Access Compliance Report

Public Rights-of-Way

(Curb Ramps)

Intersection ID: 47280	Main Street: SAVANNAH_HILLS_DR	Cross Street: LAMPLIGHTER_CLOSE_DR	Location: NW
ADA ID: FE3F31F4EE2A	Ramp Type: PerpDiag	Initial Pass/Fail: Fail	Overall Compliance: No
Severity Score: 8.75			
Codes/Mitigation Info/Possible Solution		Field Measurements/Component Compliance

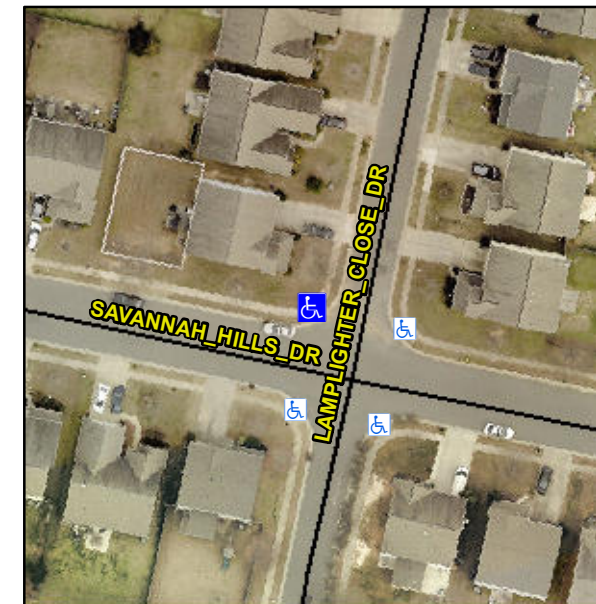
Not Found, R304.5.1

Compliance	Description	Data	Compliance	Description	Data
N/A	Ramp Length (in)	50.0	Yes	Ramp Slope (%)	6.7
No	Ramp Width (in)	44.5	Yes	Ramp XSlope (%)	0.7
N/A	Flare Type LT	N/A	N/A	Flare Type RT	N/A
N/A	Flare Slope LT (%)	N/A	N/A	Flare Slope RT (%)	N/A
N/A	Flare Traversable LT?	N/A	N/A	Flare Traversable RT?	N/A
N/A	Landing Length (in)	N/A	N/A	DWS Provided?	N/A
N/A	Landing Width (in)	N/A	N/A	DWS Contrast?	N/A
N/A	Landing Slope (%)	N/A	N/A	DWS Length (in)	N/A
N/A	Landing X Slope (%)	N/A	N/A	DWS Full Width?	N/A
N/A	Landing Curb? (Y/N)	N/A	N/A	DWS Offset (in)	N/A
N/A	Shared Landing?	N/A			
N/A	Gutter Ponding?	N/A	N/A	Gutter Slope (%)	N/A
N/A	Gutter Lip Ht (in)	N/A	N/A	Gutter X Slope (%)	N/A
N/A	Painted X Walk1?	No	N/A	Painted X Walk2?	No
	X Walk 1 Direction	To S		X Walk 2 Direction	To E
N/A	X Walk 1 Width (in)	N/A	N/A	X Walk 2 Width (in)	N/A
	X Walk 1 Slope (%)	4.6		X Walk 2 Slope (%)	1.1
	X Walk 1 X Slope (%)	1.8		X Walk 2 X Slope (%)	0.3

Remove & Replace Curb Ramp With Two New Directional Ramps or Equivalent.
